**[Docket No. FAA-2007-28688; Directorate Identifier 2005-SW-21-AD; Amendment 39-15312; AD 2007-26-10]**

#### **Airworthiness Directives; Bell Helicopter Textron Canada Model 430 Helicopters**

**ACTION:** Final rule.

Figure 1

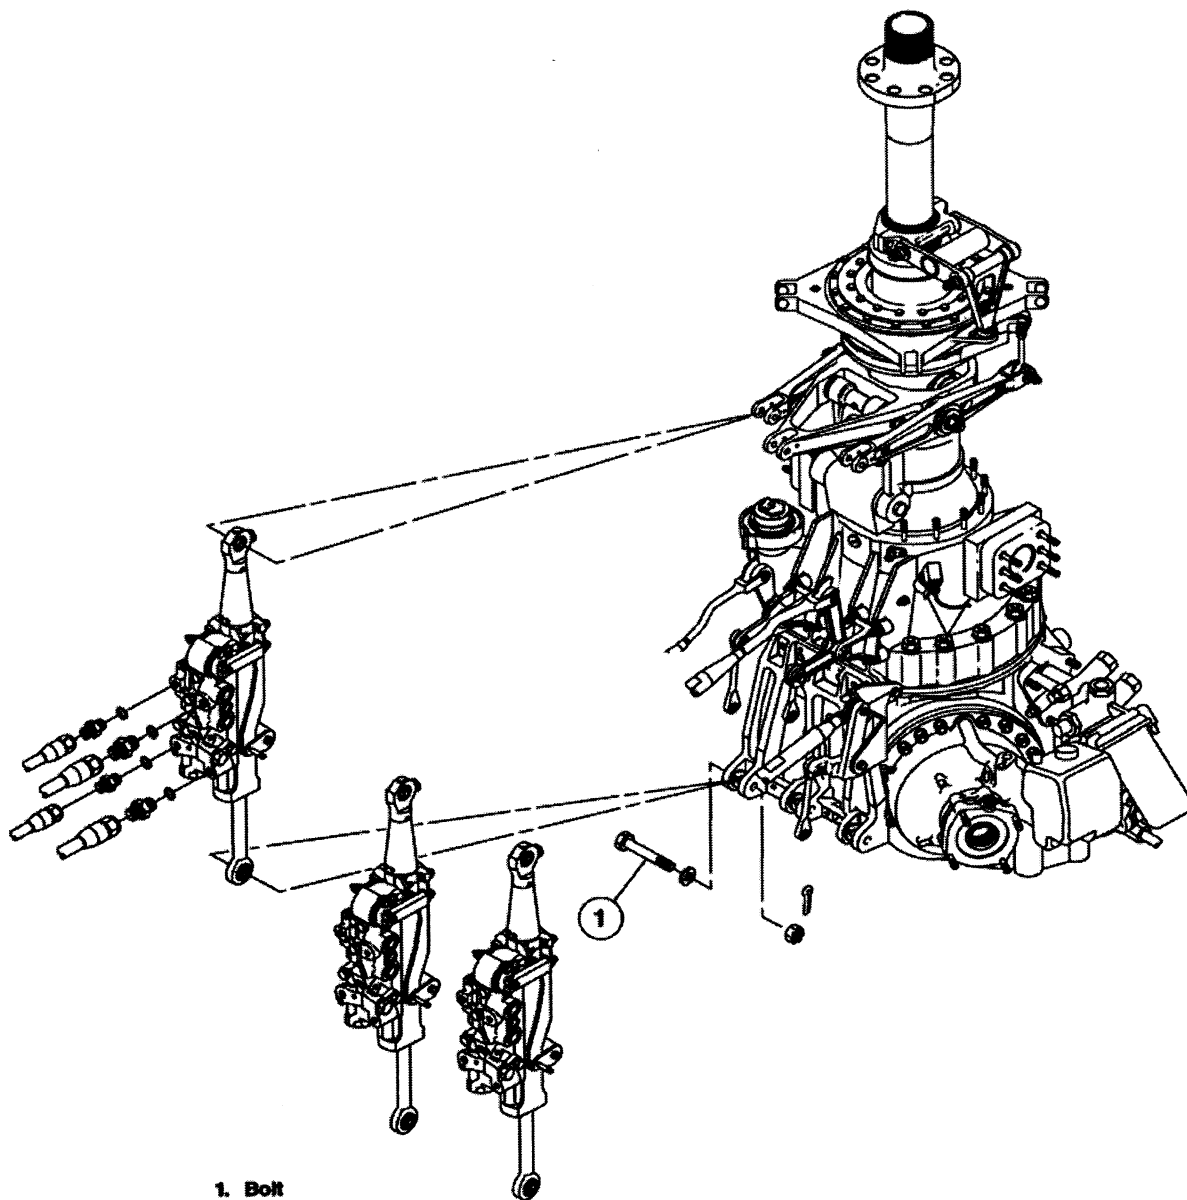
- (a) Within 150 hours time-in-service (TIS), replace all three affected bolts, as depicted for one of these bolts in Figure 1 of this AD, with airworthy, zero-time bolts, P/N 50-047C8-31.

**Note 1:** Only the right servo lower attach bolt (1) is shown. The collective and left cyclic servo lower attach bolts are also to be replaced. (This AD does not apply to the same part-numbered bolts at the upper end of each servo.)

(b) This AD revises the Airworthiness Limitations section of the maintenance manual by establishing a retirement life of 5000 hours TIS for each bolt.

(c) Record a 5000-hour TIS life limit for each bolt on the component history card or equivalent record.
